DEVELOPMENT REVIEW COMMITTEE (DRC) COMMENT REPORT

PROJECT NAME: Beach Boys Plaza

CASE NUMBER: R18011

REQUEST: Site Plan Level IV Review: 205 Room Hotel With 4,076 Square Feet of Existing Restaurant Use, 6,114 Square Feet of Existing Retail Use, 2,010 Square Feet of Additional Retail Use and 395 Space Parking Garage

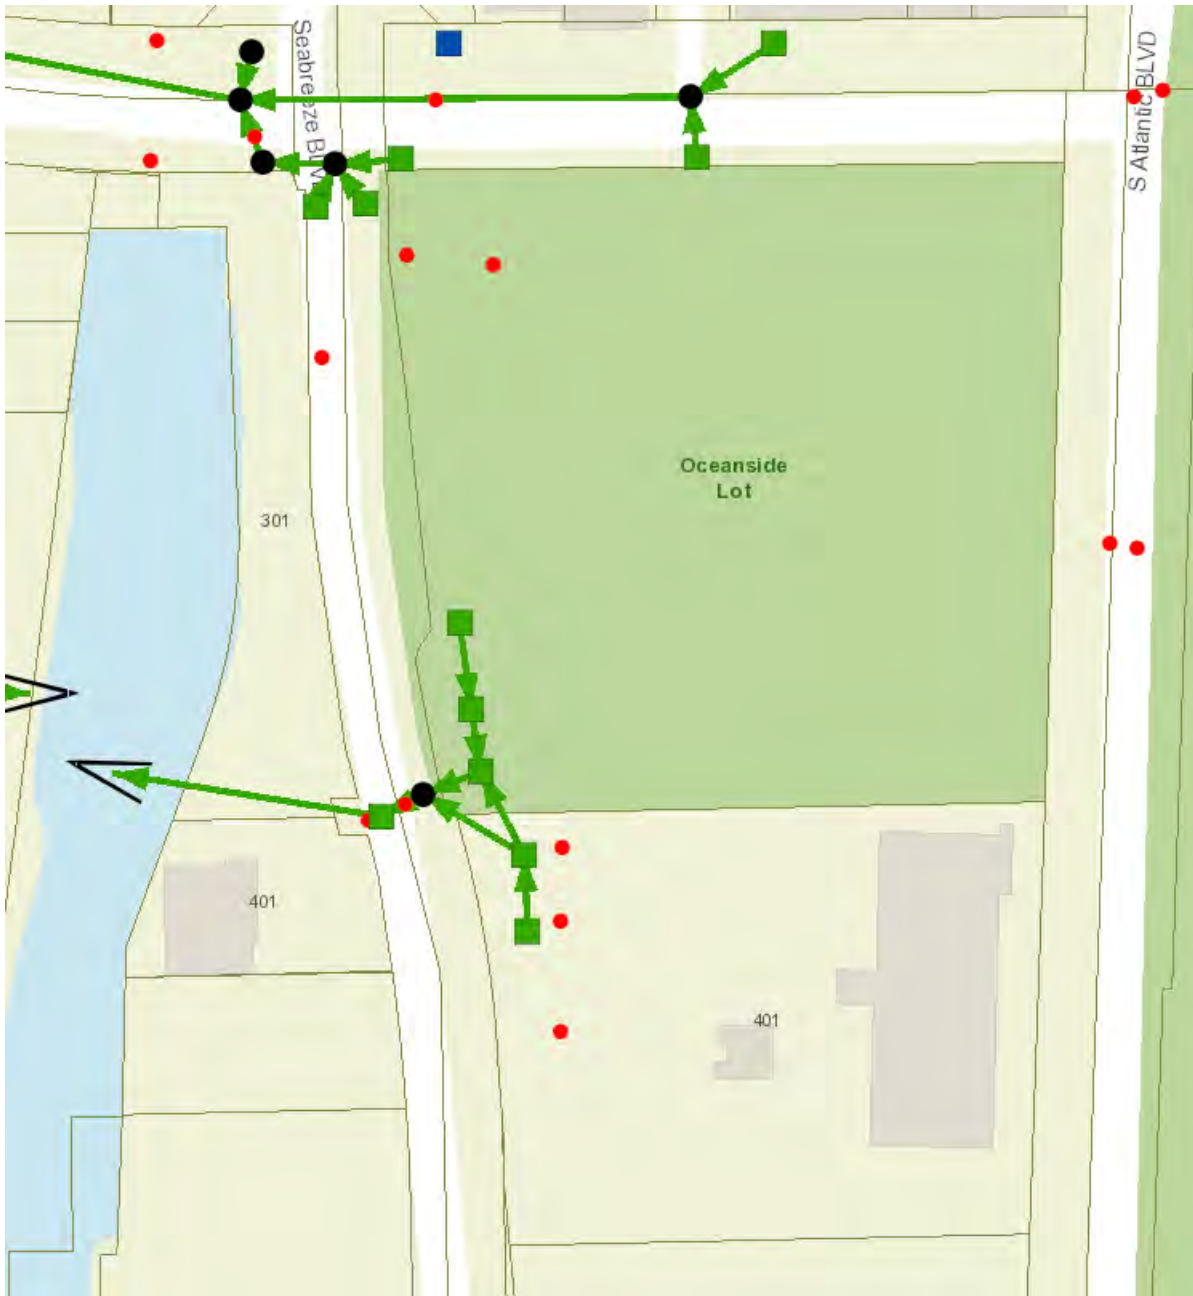
- a) The applicant shall use Broward County's latest [Plate WM 2.1 - Future Conditions](#) for determining the average wet season ground water levels to evaluate if demolition or excavation/earthwork

will require dewatering activities. The Plate WM 2.1 – Future Conditions average wet season ground water levels can be accessed through the following link:

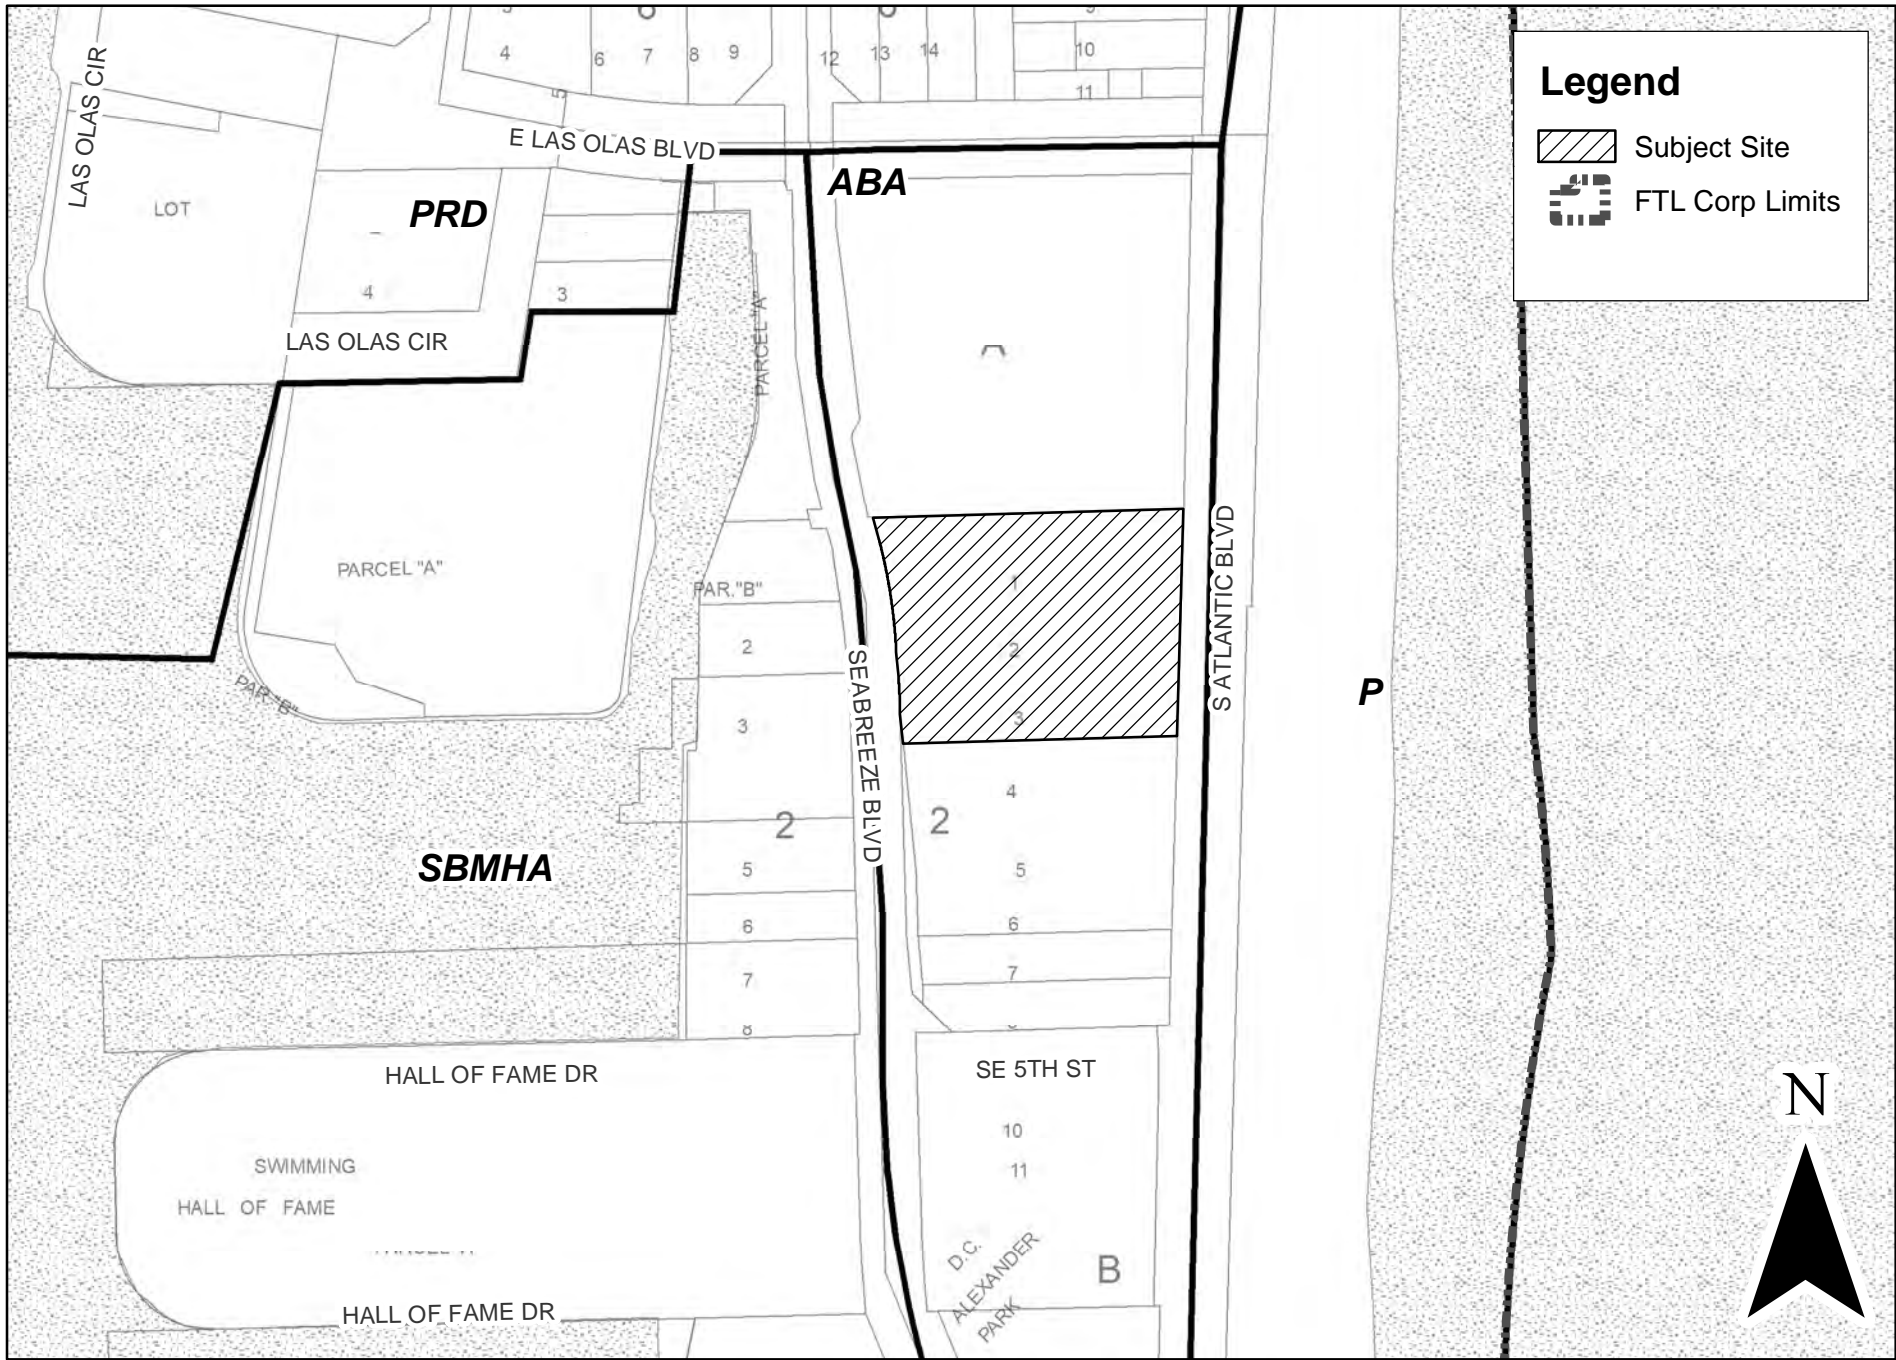
- 15) The City's Vision is to support sustainable infrastructure. Consider employing green building practices throughout the project such as, but not limited to; charging stations, solar panels, tank-less water heaters, pervious pavement where appropriate and rain collection systems to reduce potential for tidal flooding

to the west of the property. Describe how equipment on the ground floor can be protected from tidal flooding or storm surge considering project 50-year sea level rise.
